prewett
bizley
architects

39 Great James Street
125 DOC B36 - Variation of Conditions

September 2024

Proposed section showing condensing unit location (not to scale)

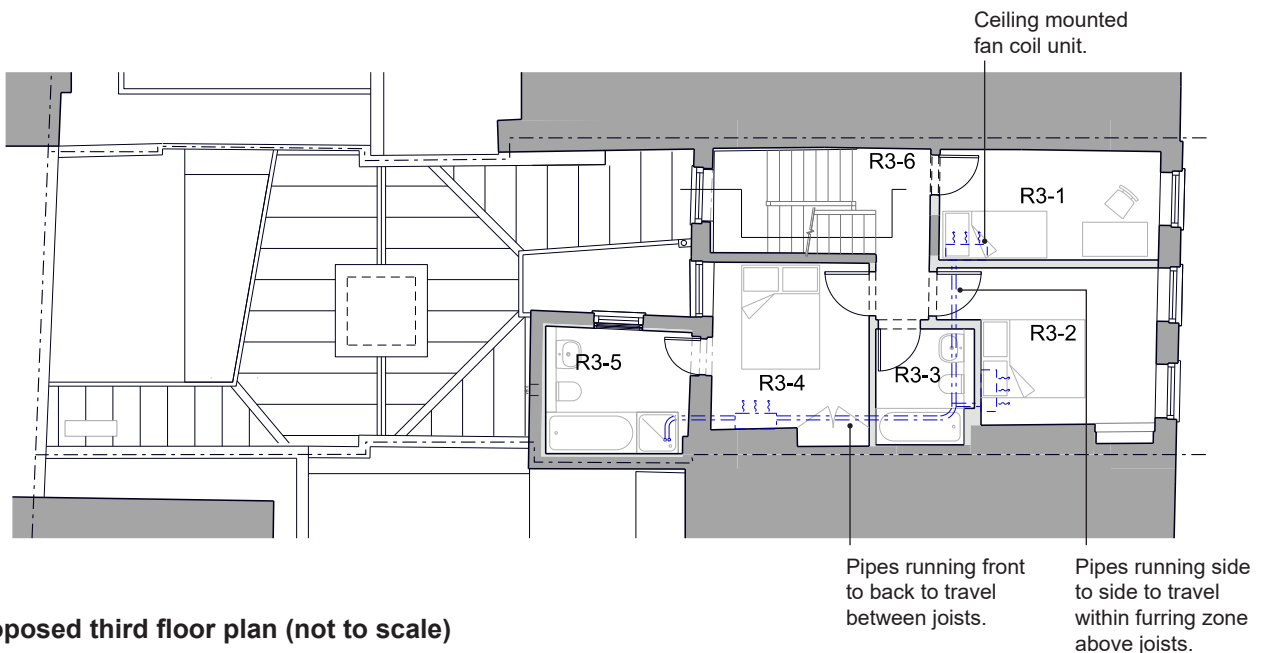
3no. air conditioning units have been proposed, with the intention of avoiding running ductwork through the listed building:

- 2no. condensing units is located on the proposed roof of the existing rear outrigger, which serve the third floor. The main roof is due to be replaced and is non-original in form. Therefore, there is no impact on historic building fabric.
- 1no. condensing unit is located on the proposed roof of the bike store and serves the basement and ground floor rear extension. The rear extension and bike store is all new building fabric. Therefore, there is no impact on historic building fabric.

None of the units are visible from the public realm and thus will result in a negligible impact on the historic conservation area context.

Axonometric view of lightwell

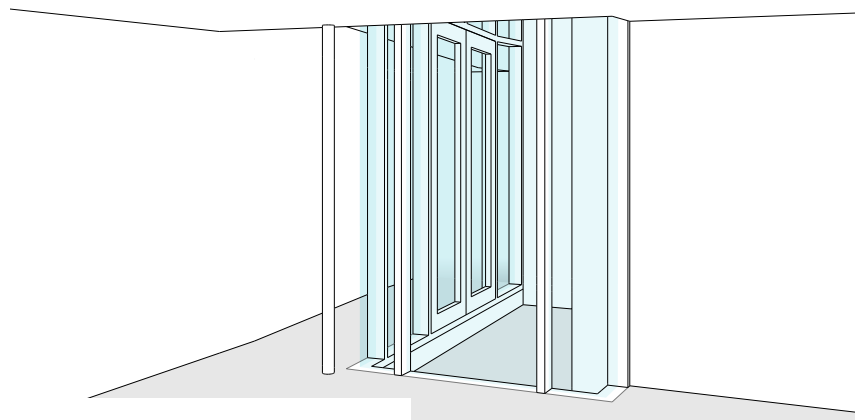
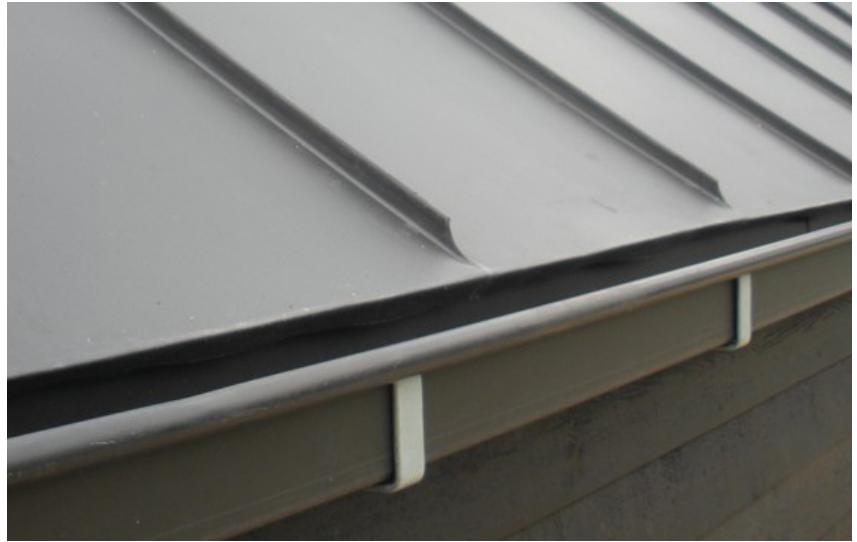
It is proposed to change the structural glazing to the rear extension lightwell to timber frame glazing and introduce a pair of doors at basement level between the lightwell and RB-5 (Cinema).

The aim of the proposal is to allow the rear extension to be more harmonious with the existing main house; the timber framed glazing would be more in keeping with the existing timber framed sash windows.

Further to the above, the smaller panes could be carried through the house, whereas the structural glazing (as currently proposed) would need to be carried over the building, which is an avoidable health and safety risk.

The proposed doors will increase ventilation to the basement and improve the usability of the lightwell space as an internal courtyard.
